S E R V I C E N O T E

OmniBER 37718 / 37719 Comms Performance Analyzer

Build Code Status 3:30 and below

Situation

Figure 1. Location of Components.

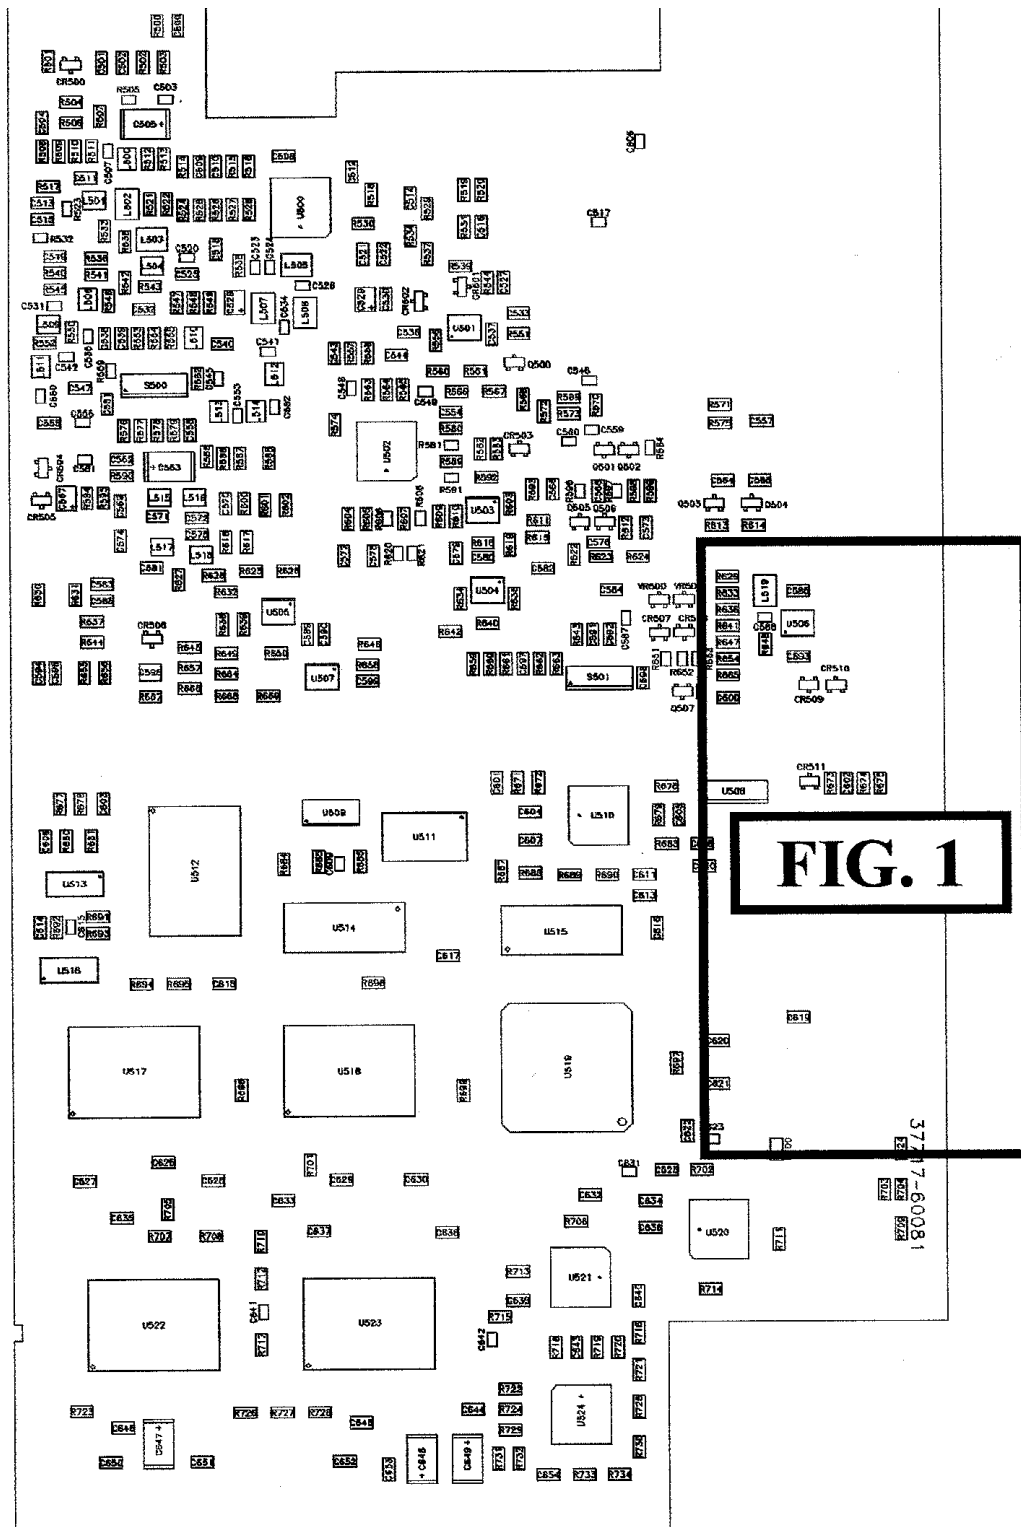
The following modification is recommended to eliminate potential overheating and premature failure of DS_n DS1 Drop (Demux) Port driver.

2. Note: Only perform this step if DSn Drop Port is defective. Remove/replace U505 (PN 1820-8942) taking note of orientation.
3. Solder a 10k ohm resistor Ra (0699-1391) to rh pin of TP8.
4. Solder a 10k ohm resistor Rb (0699-1391) to rh pin of TP8.
5. Add a wire link from vacant end of Ra to U506 pin 1 using insulated wire (see Figures 1 and 2).
6. Add a wire link from vacant end of Rb to U506 pin 7 using insulated wire (see Figures 1 and 2).

7. Reinforce with epoxy.
8. Refit module and confirm correct operation of the Drop Port as in step 1.
9. Fit a label to the rear of the instrument to indicate that this Service Note has been implemented.
10. Record the modification on CSO for future records.
